File Number: CC-27-83  
Date Received: 9/28/83  
3-Month Period Ends: 12/25/83  
6-Month Period Ends: 3/25/84  
Staff: LIT. & Staff  
Hearing Date/Item: 2/23/84 - 4b.

PRELIMINARY STAFF RECOMMENDATION ON CONSISTENCY CERTIFICATION

Applicant for Federal Permit: Texaco USA, Inc.

Project Location: On offshore lease tract OCS P-0315, approximately 11 miles west of Point Conception, Santa Barbara County (see Exhibit 1)

**FIGURE 5-1**  
**SOLID MUD**  
**COMPONENT DILUTION**  
**vs DISTANCE FROM**  
**DISCHARGE POINT**

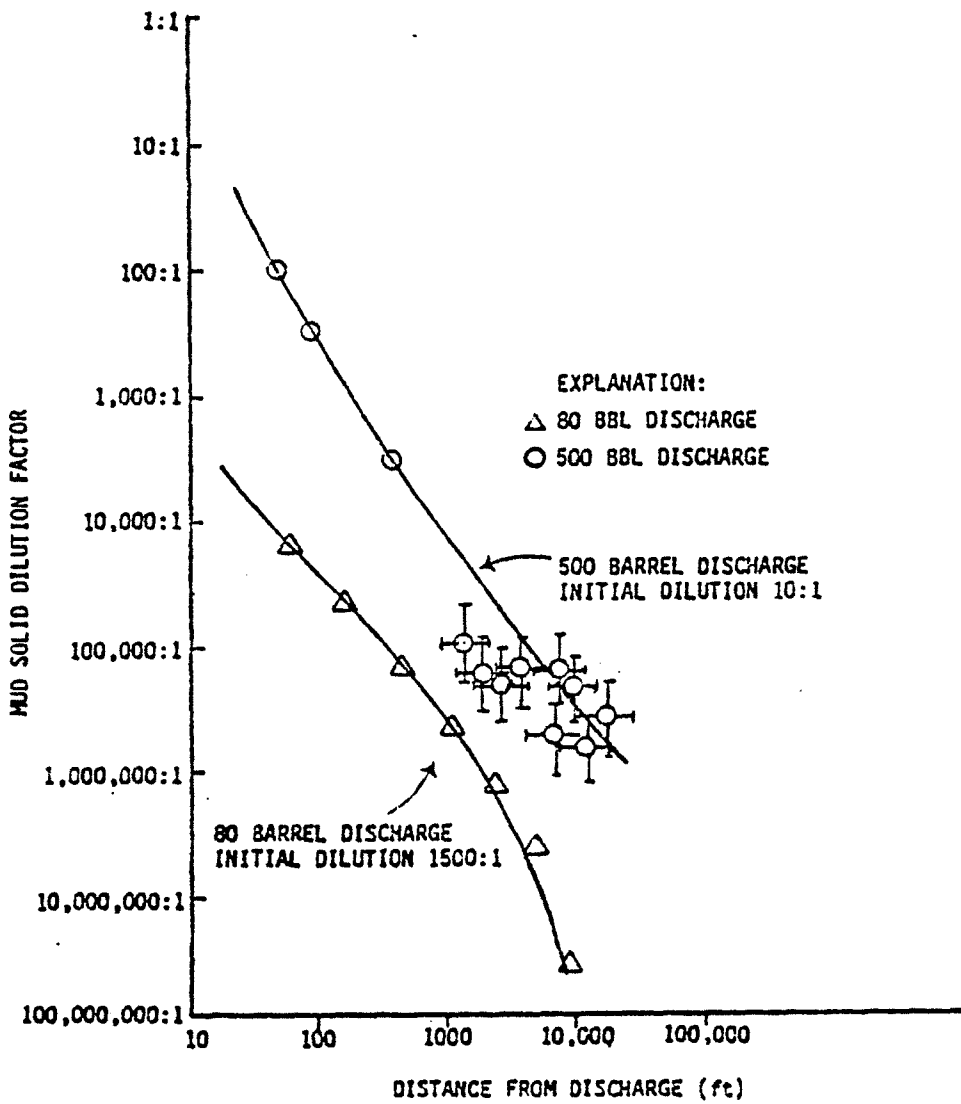
Exhibit 3 plots the mud solid dilution factor as a function of distance from discharge for both the typical and high volume discharges. The results show that the dilution of discharged muds occurs very rapidly. For example, under the Oceanic Current, a typical discharge would be diluted by approximately 450,000:1 within 3.6 hours at a distance from the discharge point of 1,293 feet. This is equivalent to a concentration of approximately .675 ppm. The 96-hour LC<sub>50</sub> value for exposure to a whole fluid, in the most sensitive species, is 100 ppm.

**BENTHIC CUTTINGS FLUX  
 FOR VARIOUS DISCHARGE DEPTHS**

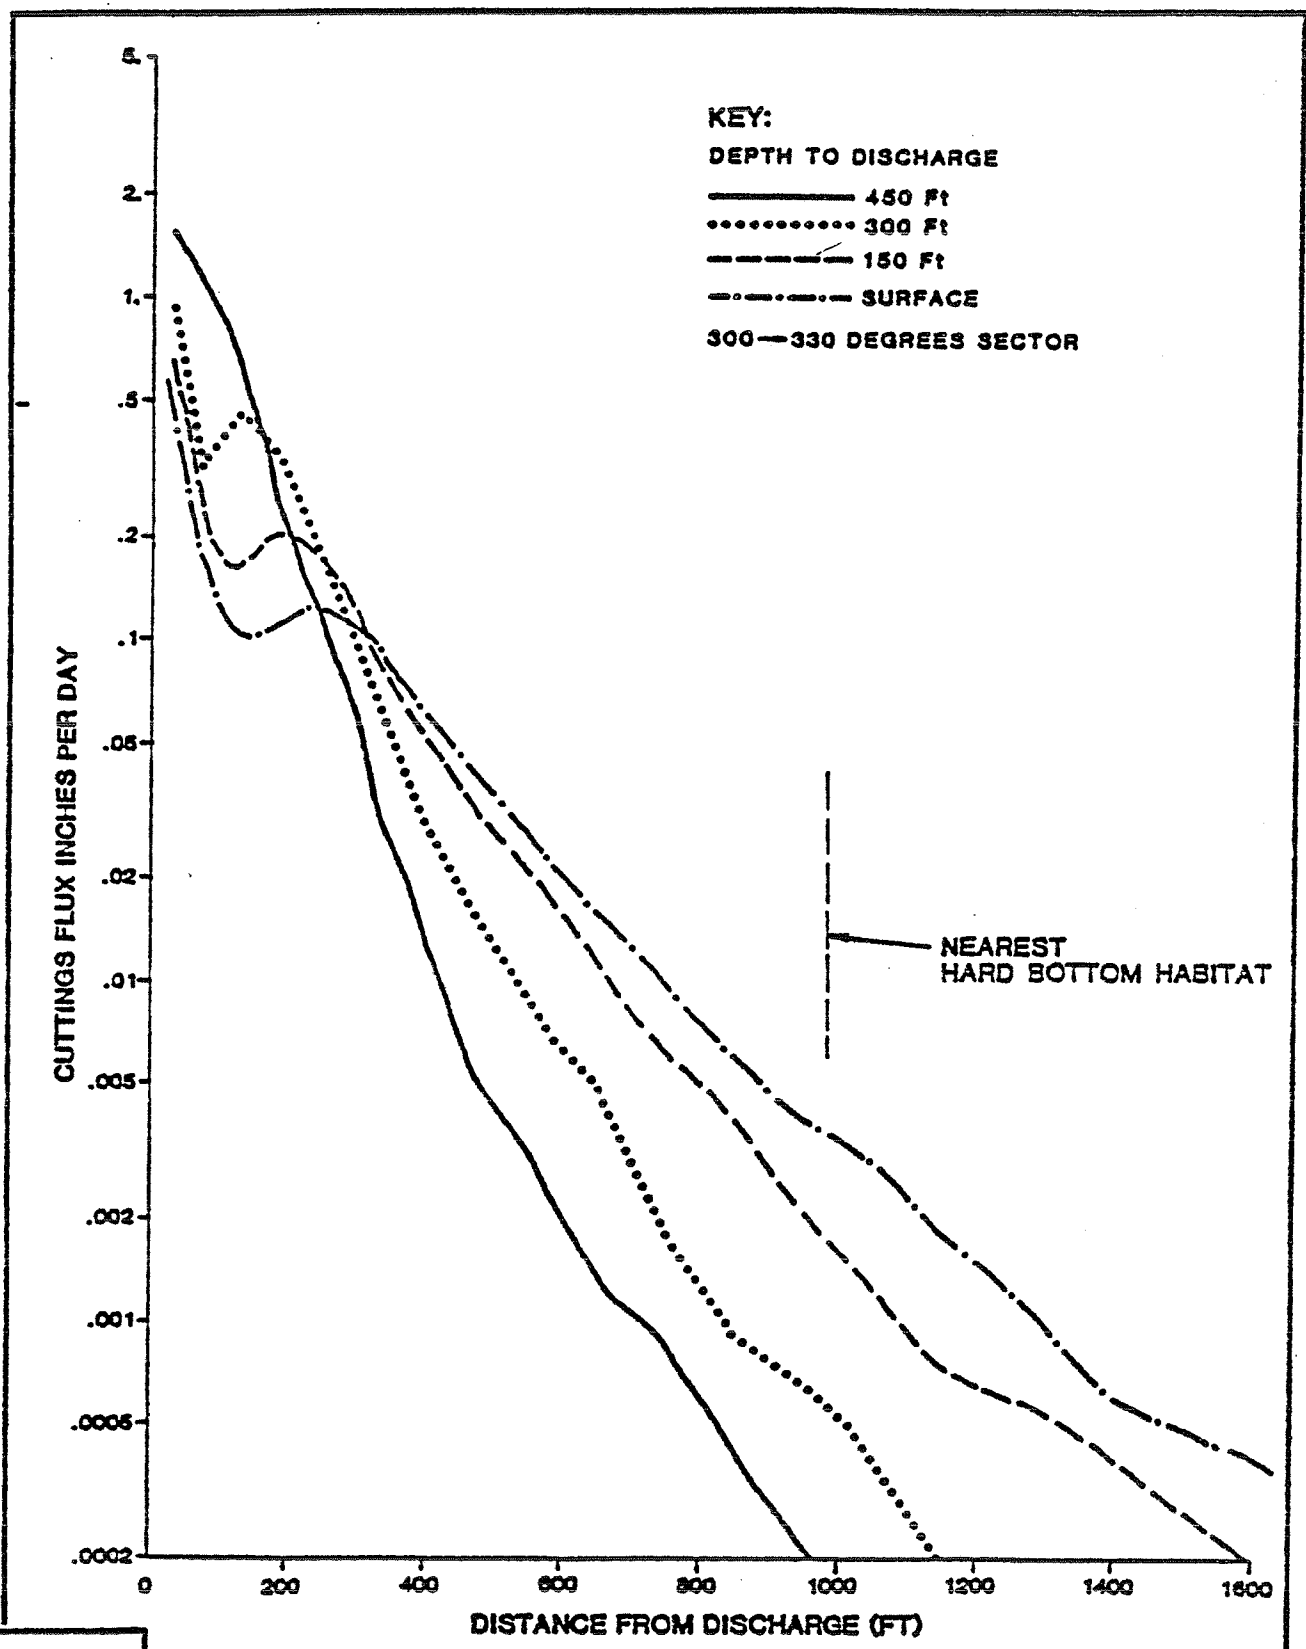
In response to a request by the Commission staff, Texaco examined three alternative discharge schemes for disposal of drilling fluids and cuttings from the platform. Dames and Moore's DRIFT drilling discharge model was applied to alternatives which included surface discharge, discharge at a 15-foot water depth, and discharge at a 450-foot water depth (the proposal is to discharge at a 300-foot water depth).

Discharge at a depth of 150 feet or on the water surface would result in increased dispersion, an increase in the area affected, a decrease in the deposition rate near the platform, and an increased deposition rate at the nearest hard bottom habitat. As indicated on Exhibit 6, the predicted deposition rate at nearby rock outcrops is greater than that associated with Texaco's proposed alternative and affects more of the outcrop area. Because the surface discharge could also adversely affect phytoplankton productivity and Texaco's proposed alternative would not (the proposed discharge is below the euphotic zone), impacts associated with a surface discharge are considered greater. The 150-foot discharge alternative would slightly increase the predicted deposition rate in the hard bottom area, and could affect a larger portion of that area. For this reason, it too is considered more environmentally damaging than Texaco's proposed discharge system.

Based on this analysis, Texaco's proposed discharge through a vertical pipe at the 300-foot water depth is considered the least environmentally damaging of the alternatives considered. A very rough estimate of the total depth of cuttings flux which would be deposited 1,000 feet from the platform can be obtained by multiplying the total number of days of drilling by the deposition rate in inches per day. The result, which assumes that all cuttings deposited would not move, which they likely would, is .63 inches. The figure could be wrong by at least one order of magnitude. Measurements of the benthic habitat should be made to determine if any potentially dangerous changes are occurring. The monitoring program proposed by Texaco will make these measurements.

**PROPOSED TRAFFIC  
SEPARATION SCHEME  
WESTERN SANTA BARBARA  
CHANNEL**

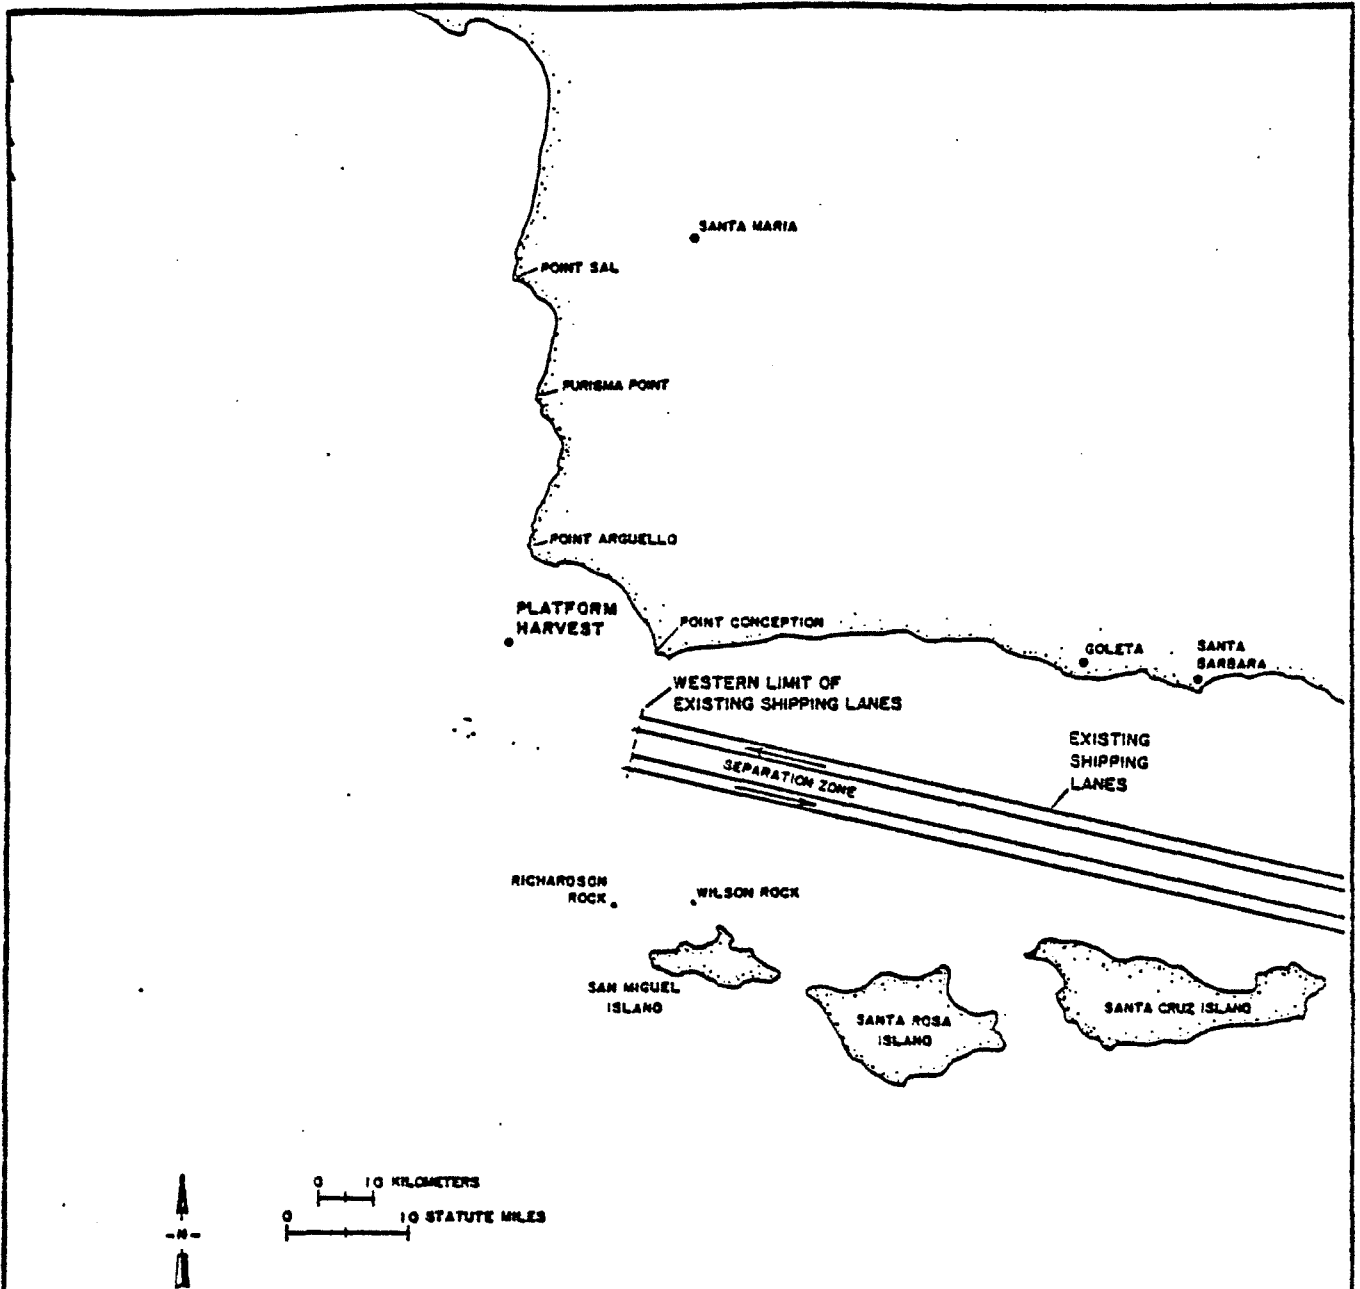
Platform Site. Texaco proposes to site Platform Harvest approximately eleven miles northwest of the Santa Barbara Channel Vessel Traffic Separation Scheme (VTSS) (see Exhibit 7). Although there are no platforms currently in the area, four platforms, including Harvest, are planned for the area. Chevron's Hermosa, proposed to be located approximately 11,000 feet (approximately two miles) east of Harvest, has already been certified by the Commission.

In response to these concerns expressed by the Commission, Texaco agrees to several additional mitigation measures beyond those proposed in the DPP. One measure includes installing an Automatic Radar Plotting Aid (ARPA) on Harvest. The ARPA tracks up to 60 ships, tells the radar operator what the closest point of approach between a ship and the platform will be, and how much time there is to the closest approach point. It also displays the speed and course of the ships. An inner and outer guard zone can be selected by the radar operator, and if a ship penetrates the guard zones, both visual and audible alarms are automatically activated.
